02-AFC-4C

Subject: **WALNUT ENERGY CENTER (02-AFC-4C)**
DATA RESPONSES

DATA RESPONSES OF WALNUT ENERGY CENTER AUTHORITY (WECA)¹

Graph 14.1 – Water and Generation (5 selected months)⁷

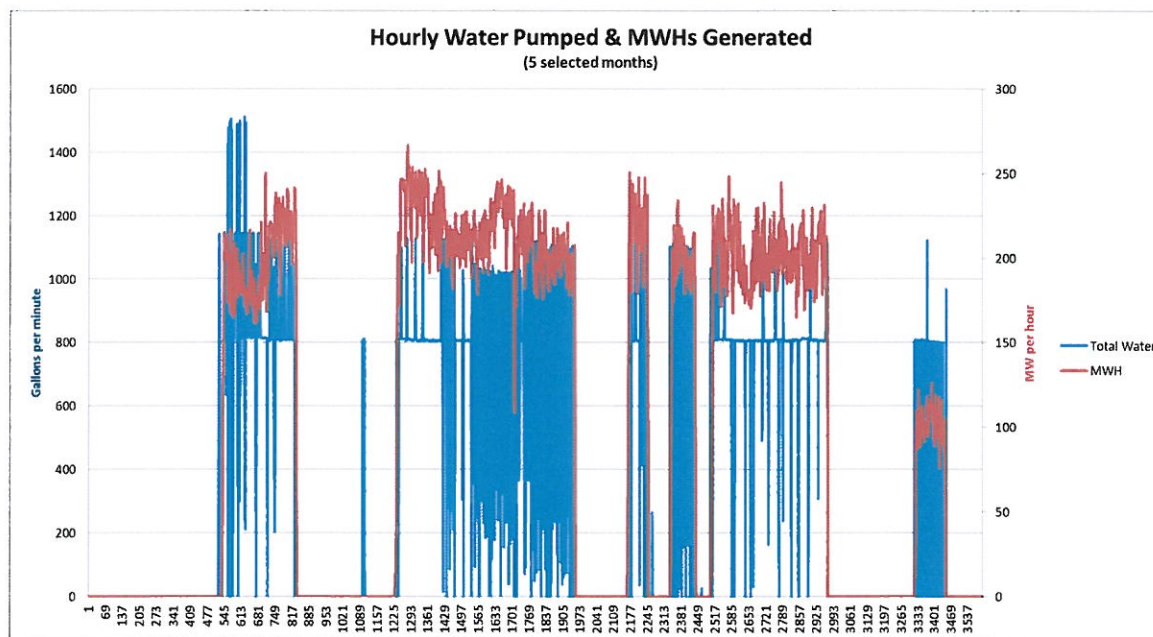
14. Please provide a correlation between the generated power and the source of the water used to generate that power, show how the calculations were made, and explain any assumptions made to provide the correlation.

The following graphs 14.1 and 14.2, showing water use in gallons per minute in relation to megawatt hours generated, illustrate the correlation between load and water usage.

To improve assessment of correlation, a subset of the data was created wherein all of the hours where no generation occurred are eliminated, and a 12-hour moving average of the average hourly gallons per minute and average Megawatts per hour was calculated. The Correlation function in Microsoft Excel was then used to calculate a correlation factor based on the following equation:
